Common Structural Rules for Bulk Carriers and Oil Tankers

Technical Background for Urgent Rule Change Proposal 1 to 01 JAN 2021 version

Pt 1, Ch 8, Sec2, [3.1.2]: Ratio of b_f to h_w for Angle, L2 and T-bars

Figure 1: Results for some stiffened panels with varying ratios of b_f/h_w

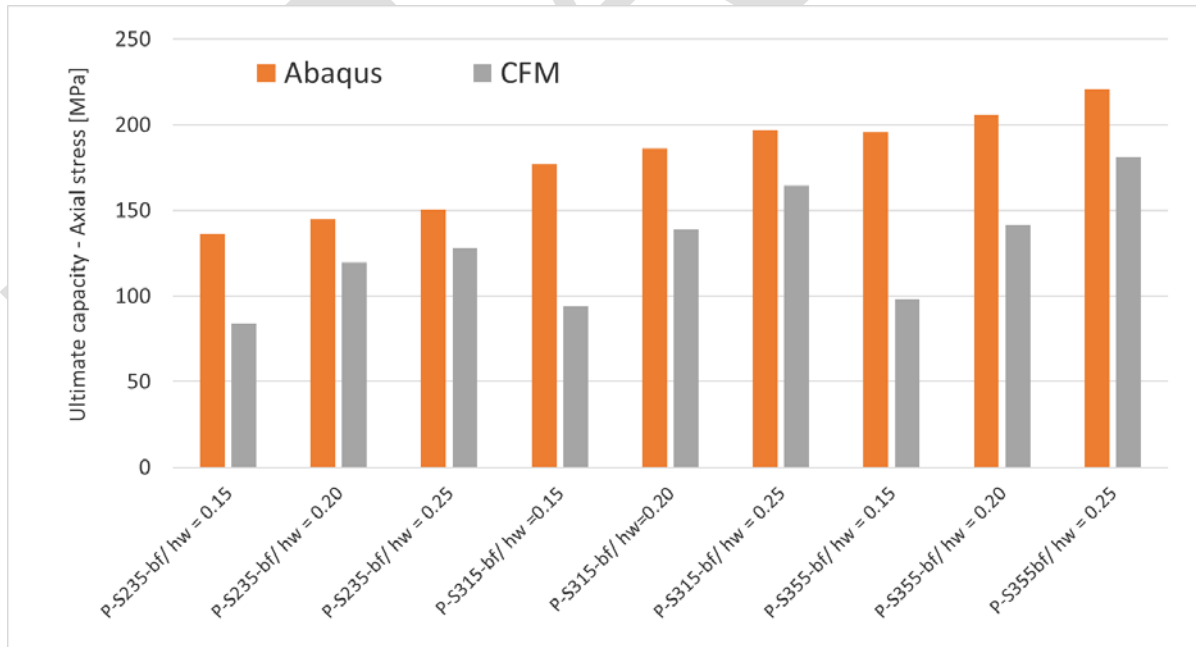
The effect of the relaxation is verified by comparisons with nonlinear FE calculation(Abaqus). For these comparisons, calculated results are shown in Figure 1 for some selected stiffened panels with T-bar stiffeners. The dimensions of the panels are given in Table 1, where the thicknesses for the plate and web are close to the minimum rule required thicknesses in order to minimize the rotational restraint as expected for this specific investigation. The plates are loaded with a uniaxial load in the stiffener direction which is the most critical load case for torsional buckling.

In Figure 1, it shows that with a smaller ratio of b_f/h_w , the CFM formula becomes more conservative, which means that even with this proposed relaxation the rule as a whole is still on the safe side. However, further relaxation of the proposed ratio $b_f/h_w \geq 0.2$ is yet to be investigated more extensively since the slenderness requirements on the stiffener webs of T and angle bars are dependent on the assumed simply-supported restraint from flange plate.

In the current CSR, there is a requirement on the ratio $b_f/h_w \geq 0.25$, which came originally from CSR OT (July 2010) and takes as a general requirement to prevent torsional instability of angle and T profile stiffeners. However, since torsional buckling of stiffeners is also checked against specific design loads in the buckling capacity closed-form interactive formula (CFM) of CSR Pt 1, Ch 8, Sec 5, [2.3.4], it is proposed to introduce a modest relaxation on this general requirement as $b_f/h_w \geq 0.2$.
